Technical Service Information Bulletin

AUDIO DOOR OPENING/CLOSING EFFORT IMPROVEMENTS

'02 – '05 SC 430

BODY
B0001-05

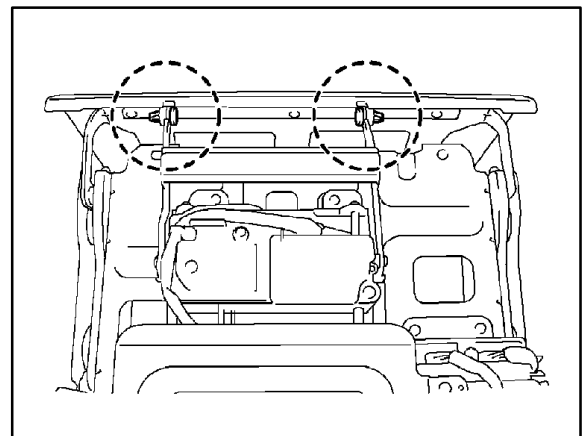
- A. Remove the 2 clips shown in the illustration.

It is OK to cut the clips as new ones are provided in the service parts kit.

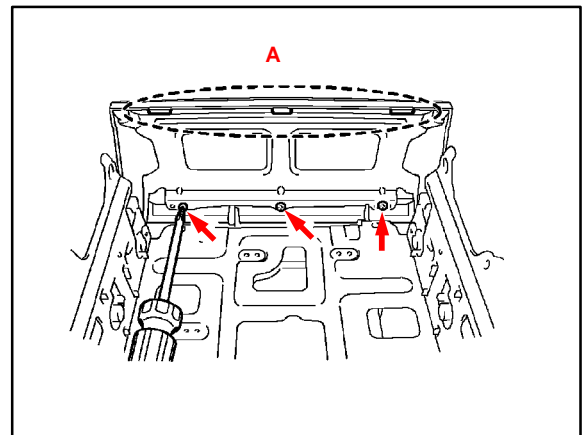
- B. Remove the 3 screws from the backside of the instrument cluster finish panel CTR LWR and then remove the instrument cluster finish panel CTR LWR.

Be careful not to damage the 3 positioning ribs in area A.

- C. Install the original instrument cluster finish panel CTR LWR onto the new instrument cluster finish panel sub-assembly LWR CTR.
- D. Tighten the 3 screws.

**Torque: 0.69 to 0.71 N•m
(6.83 to 7.24 kgf•cm,
0.49 to 0.52 ft•lbf)**
